PRIVATE PLAN CHANGE 101
ADDENDUM HEARING REPORT
167-173 PILKINGTON ROAD, PT ENGLAND
WYBORN CAPITAL INVESTMENTS LIMITED

Addendum to the Section 42A Hearing Report for Proposed Private Plan Change 101: Pilkington Park Precinct to the Auckland Unitary Plan (Operative in part)

Addendum Report date: 25 November 2024

Report author: Michele Perwick, Senior Policy Planner, Auckland Council

Figure IX6.2.3.1 and IX6.3.2.1: viewing distance to the rail corridor.

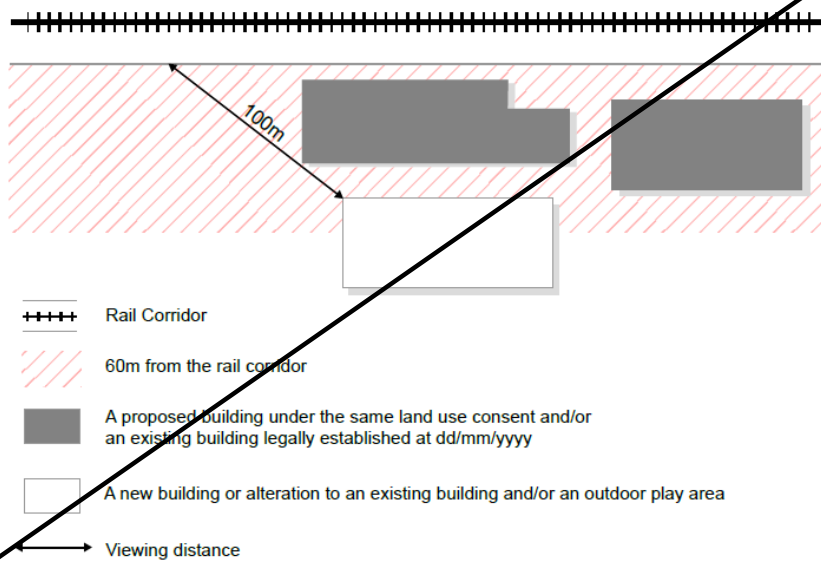
Commented [B&A38]: KiwiRail (5.14).

Commented [B&A39]: KiwiRail (5.14).

IX.10.1 Pilkington Park Precinct: Precinct Plan 1:

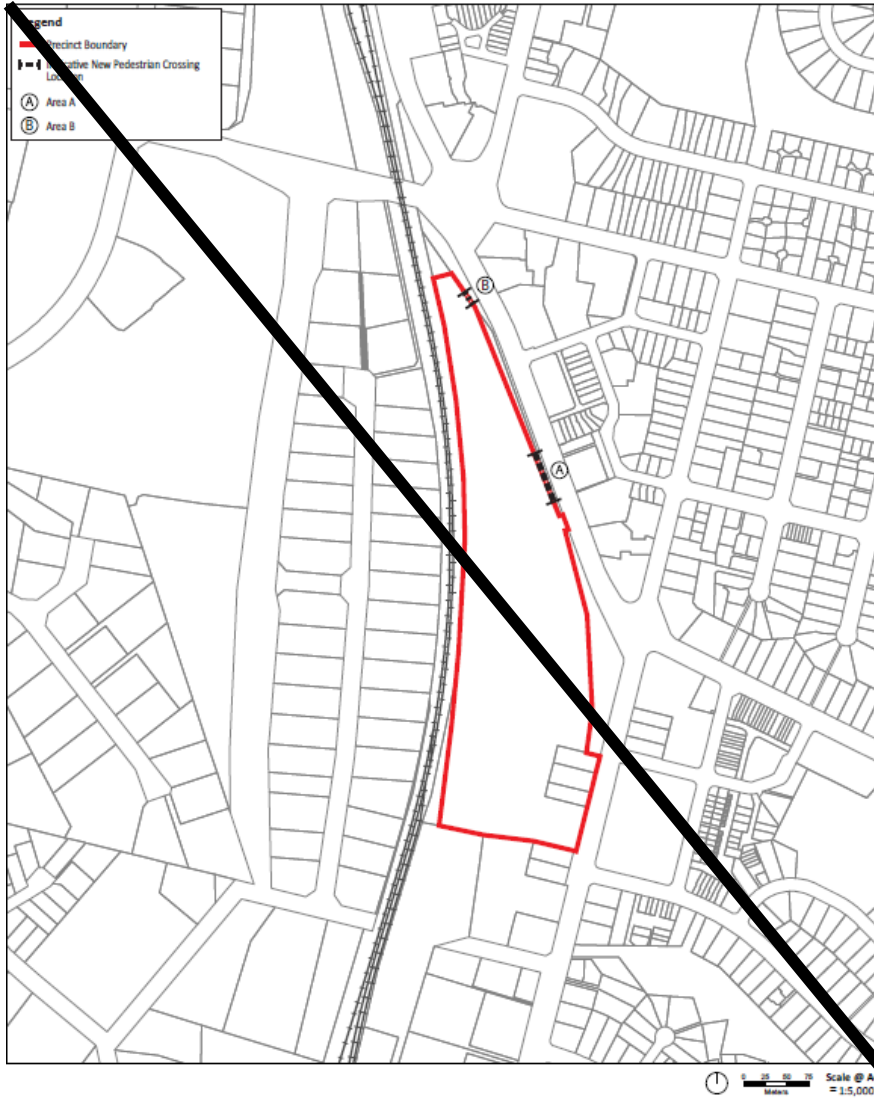
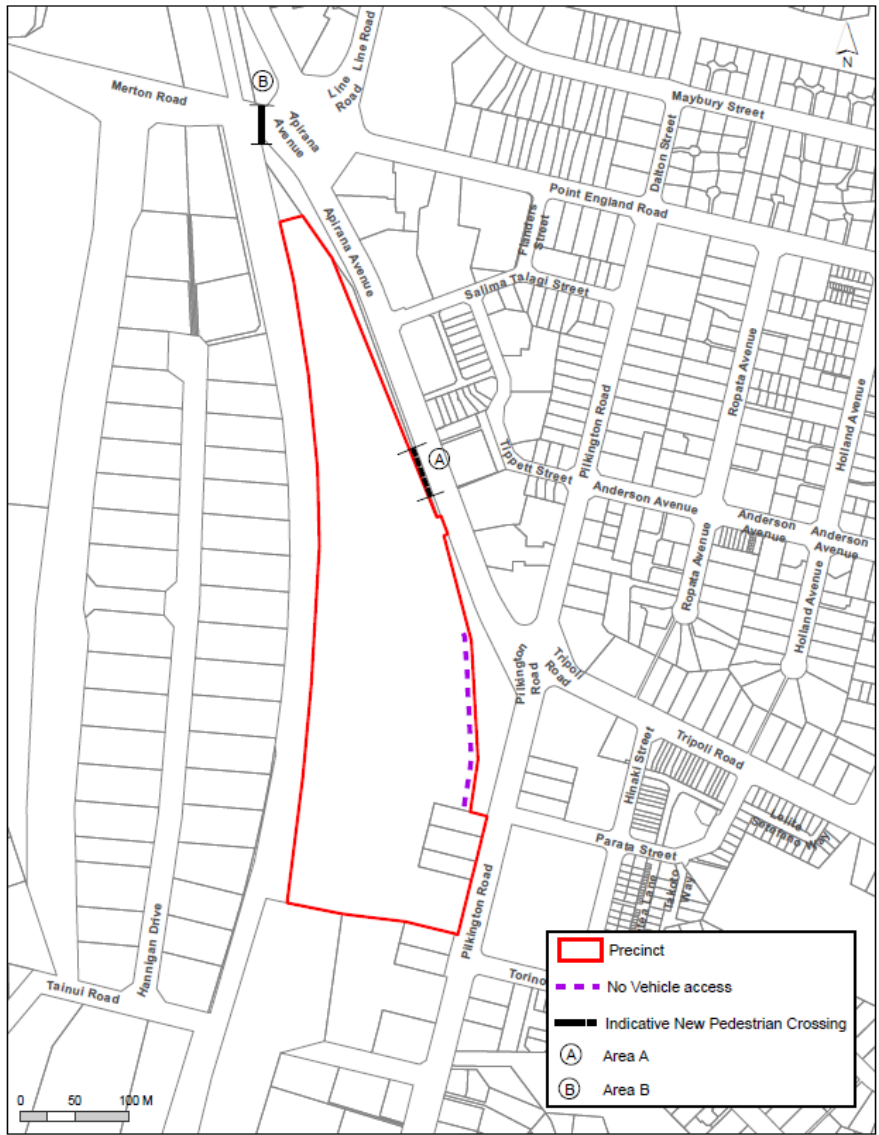
- k. Amendments to the s42A recommended precinct plan to show the proposed pedestrian crossings and to remove reference to vehicle access restrictions.

37. Mr Collins, council's traffic consultant in his Addendum Review and Mr Robert Lee, in his evidence for AT, both consider that two crossings should be provided - one at the intersection of Merton Road and Apirana Avenue and the other further along Apirana Avenue opposite Talbot Park. While both specialists seek similar changes to the standard and the precinct plan, I support Mr Collins recommendations as it recognises the need for a shared pedestrian and cyclist crossing on Merton Road crossing.

22. I recommend that amendments are made to the **IX.6.5. Pedestrian crossing** and **Precinct Plan 1**, contained in Attachment A to Mr Roberts and Ms Zhai's evidence, to address pedestrian and cyclist accessibility between the site and the Glen Innes train station and Town Centre.

Figure 3: Point England Road approach to the Apirana Avenue/Merton Road roundabout, showing the pedestrian route proposed by Mr Parlane (source: Googlemaps)

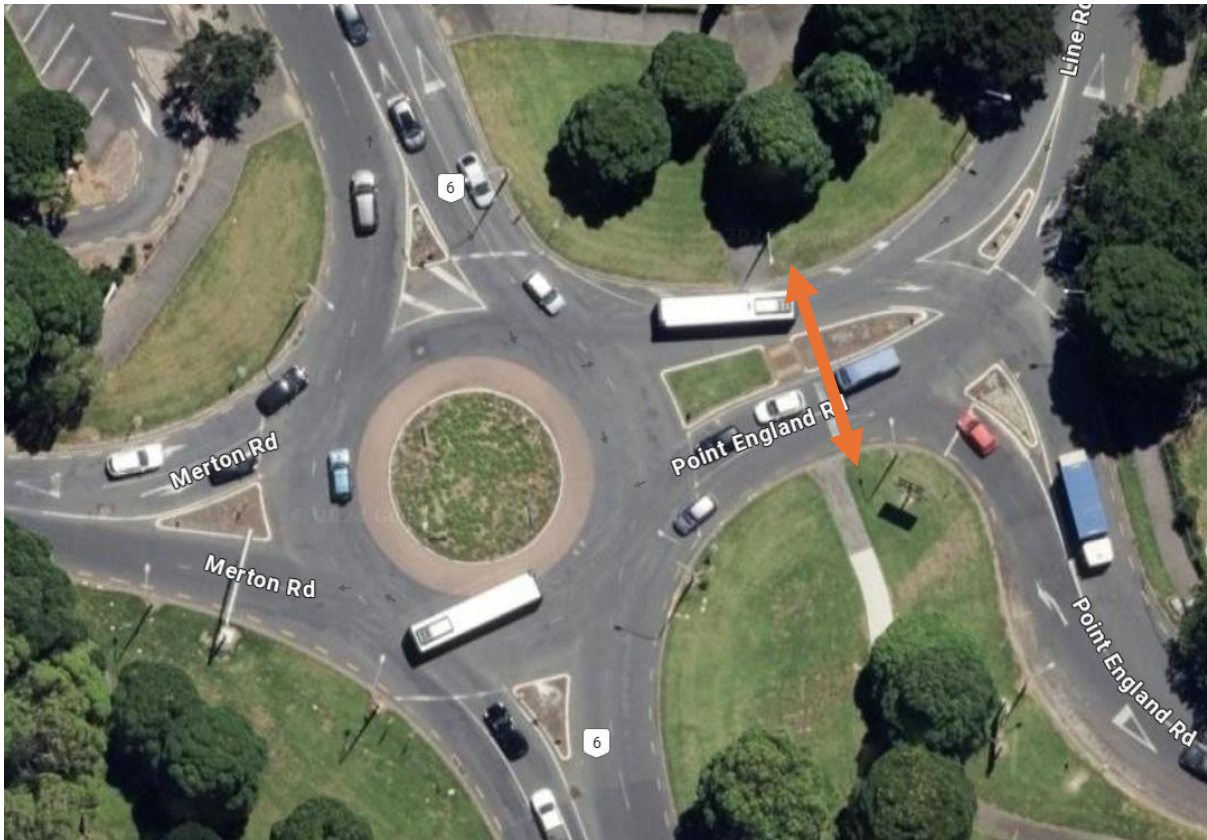
7. In my view, the alternative crossing suggested by Mr. Parlane does not fully address pedestrian and cyclist access to Glen Innes as it does not provide:
 - a. a safe pedestrian crossing of the Point England Road arm of the Apirana Avenue/Merton Road/Point England Road roundabout, which is multilane and has complex vehicle turning movements due to the convergence of Line Road and Point England Road, as shown in Figure 3.
 - b. Cyclist accessibility, as there are no cycle facilities located on the eastern side of Apirana Avenue.

8. Auckland Transport's Links to Glen Innes project will deliver a raised pedestrian crossing on Point England Road, refer to Figure 4. Without this improvement I consider that the pedestrian route proposed by Mr Parlane is not suitable to enable safe pedestrian access to the site, and that this route is likely to either suppress pedestrian trips, increase the safety risk for pedestrians, or both.

9. As Auckland Transport has recently constructed a cycleway along the western side of Apirana Avenue, I consider it more appropriate that the developer form a shared pedestrian and cyclist crossing on Merton Road, if Auckland Transport has not already done so when the site develops. This will provide safe access for pedestrians and cyclists between the site and the Glen Innes Town Centre and train station.

Figure 4: Auckland Transport Links to Glen Innes project - Apirana Ave/Merton Rd roundabout

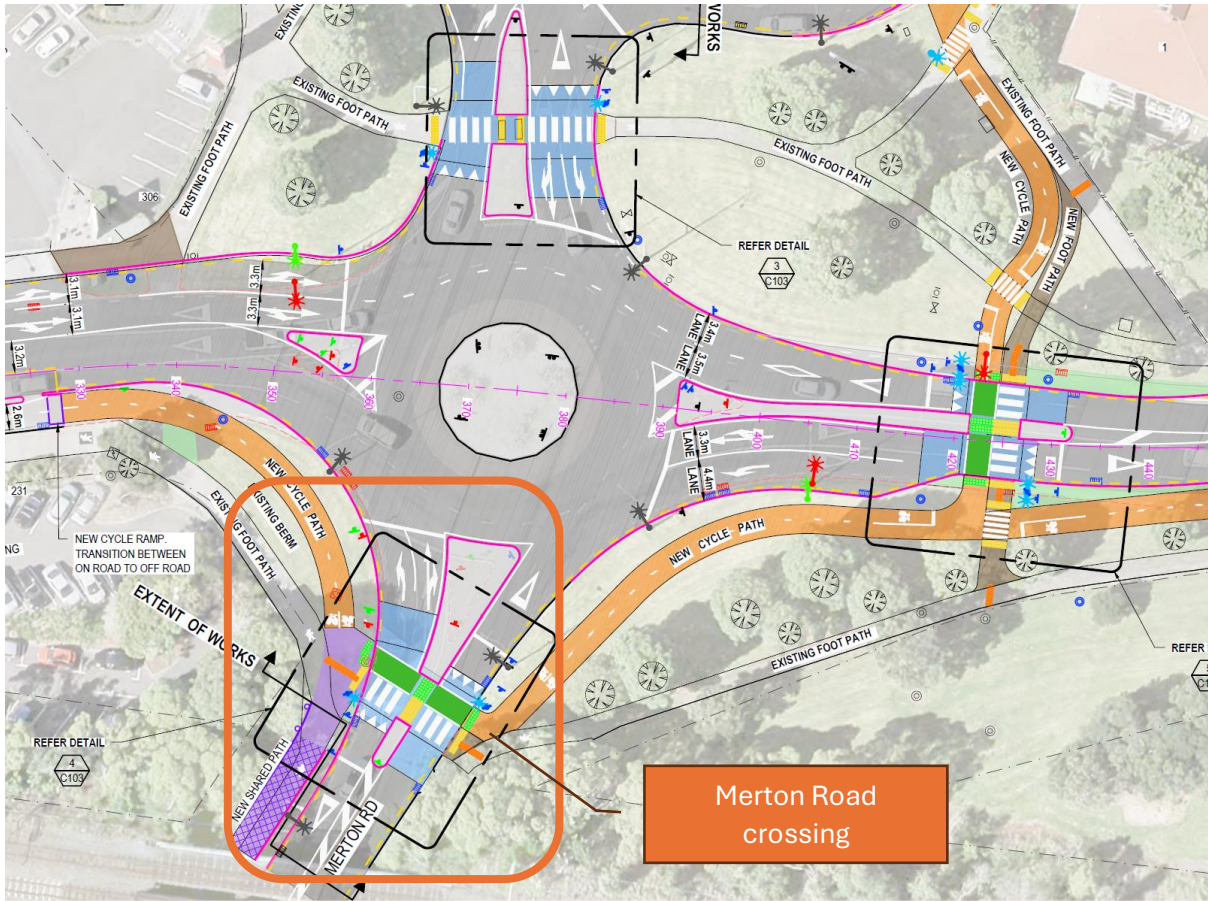
10. In paragraph 85 of his evidence, Mr Parlane's expresses concern that building the Merton Road crossing prior to Auckland Transport delivery the Links to Glen Innes Cycleways project may introduce a pre-built constraint that would need to be removed by Auckland Transport.

11. I disagree with this concern. Auckland Transport has construction drawings for this crossing, which the developer could adopt and deliver. The Merton Road crossing is shown in Figure 4.

12. I therefore recommend the following changes to Standard **IX.6.5. Pedestrian crossing**, contained in Attachment A to Mr Roberts and Ms Zhai’s evidence:

1. Prior to the occupation of any new dwelling, one two new pedestrian active modes (zebra) crossings shall be constructed and operational. The location of the pedestrian crossing shall either be:
 - a) A pedestrian crossing generally Generally at the location shown as Area A on Precinct Plan 1; and where a pedestrian crossing at the Merton Road and Apirana Avenue intersection has been constructed; or
 - b) A pedestrian and cyclist crossing generally Generally at the location shown as Area B on Precinct Plan 1 in the event that a pedestrian crossing at the Merton Road and Apirana Avenue intersection has not been constructed.
